# PARTS & SERVICE NEWS

REF NO.	AT04802
DATE	May 14, 2004

**SUBJECT:** REPAIR PROCEDURE FOR GRAMMER'S SEAT WITH AJSS ON WA700-3, 800-3, 900-3 AND 1200-3

**PURPOSE:** To introduce modification procedure to repair GRAMMER's operator's seat on the AJSS spec. WA700-3, 800-3, 900-3 and 1200-3 wheel loaders

Fig. 1

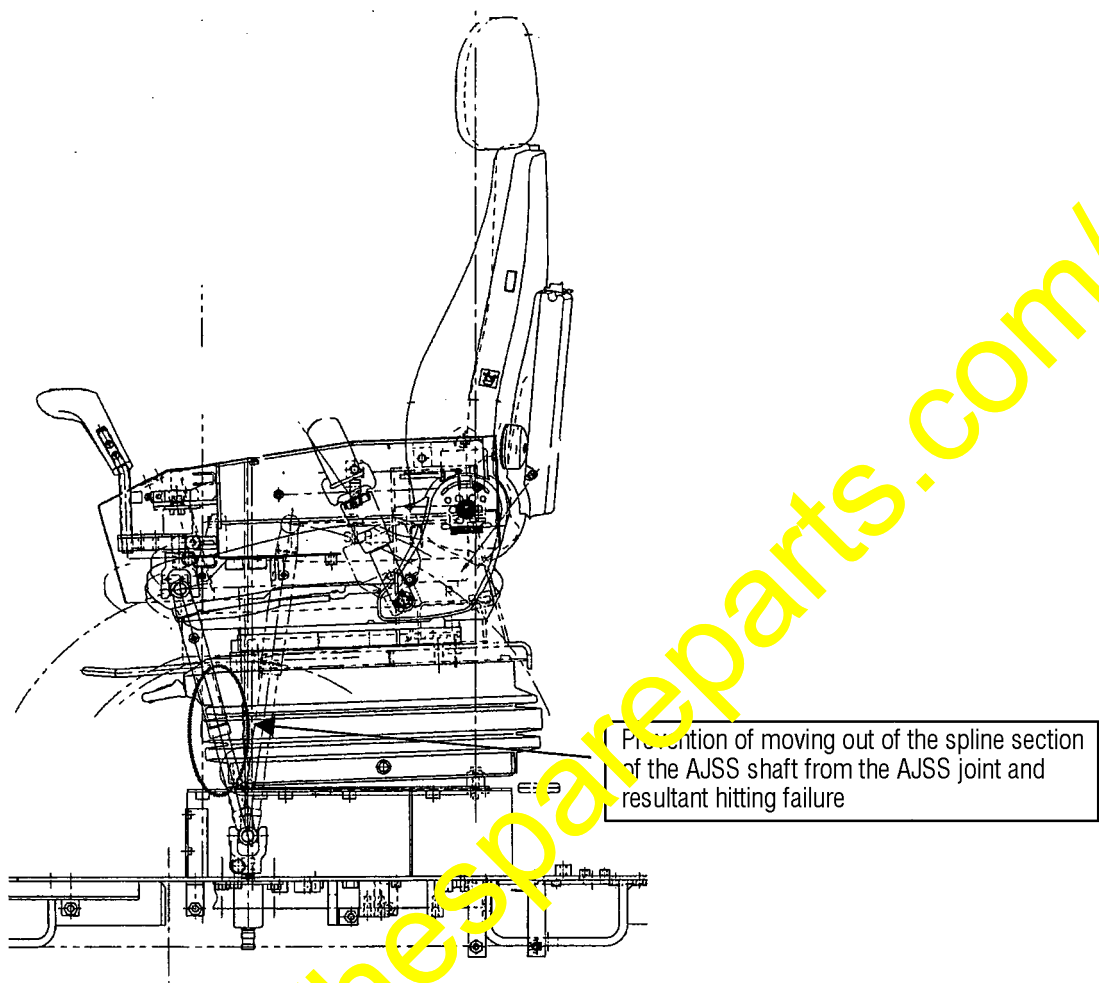
- (1) The positions of the suspension stoppers (the highest position and the lowest position) for the operator's seat have been changed to prevent the spline section of the AJSS shaft from moving out and hitting.

Fig. 2

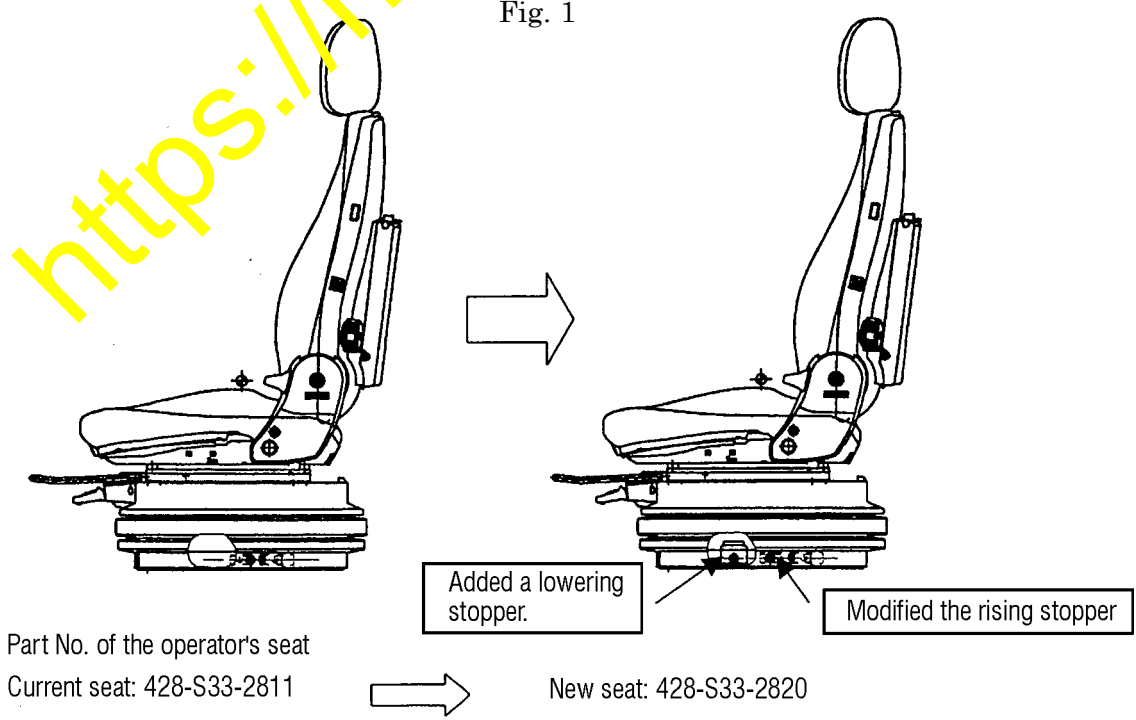
Part No. of the operator's seat  
Current seat: 428-S33-2811

New seat: 428-S33-2820

Fig. 3

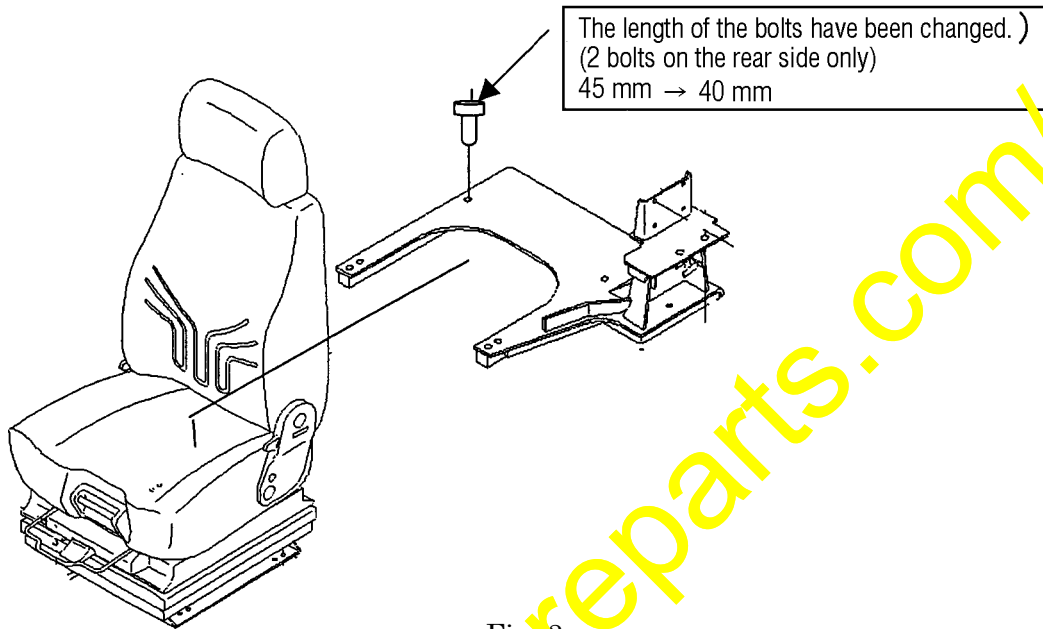
- (2) The length of the AJSS bracket mounting bolts have been changed to prevent occurrence of interference between the bolt and the suspension.

(Failure phenomenon)

Interference occurs between the bolt and the suspension link to shorten the suspension stroke.

Current bolt: Part No. 01252-70845

New bolt: Part No. 01252-70840

Fig. 5

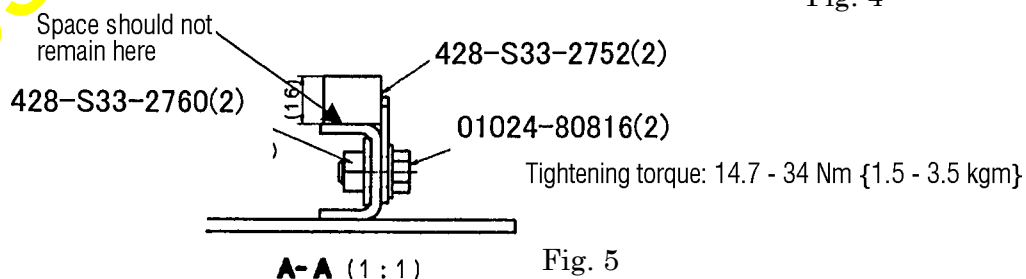
- Add the suspension stoppers (lowering stopper). (On both of the LH and RH sides)

Tightening torque: 14.7 - 34 Nm {1.5 - 3.5 kgm}

Fig. 6

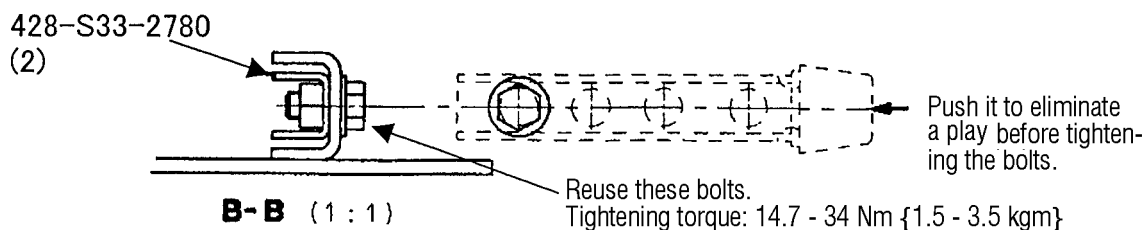
- Replace the suspension stoppers (rising stopper). (On both of the LH and RH sides)

Reuse these bolts. Tightening torque: 14.7 - 34 Nm {1.5 - 3.5 kgm}

Photo. 3

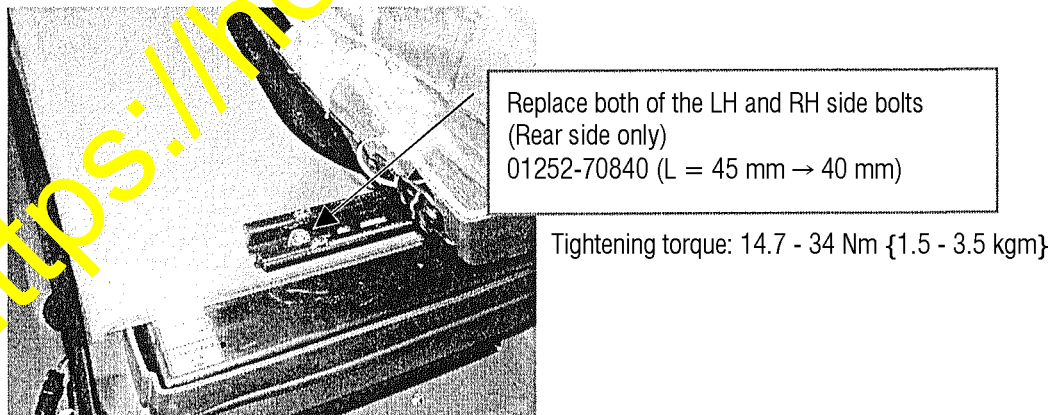
- Replace the 2 bolts on the rear side of the AJSS bracket.
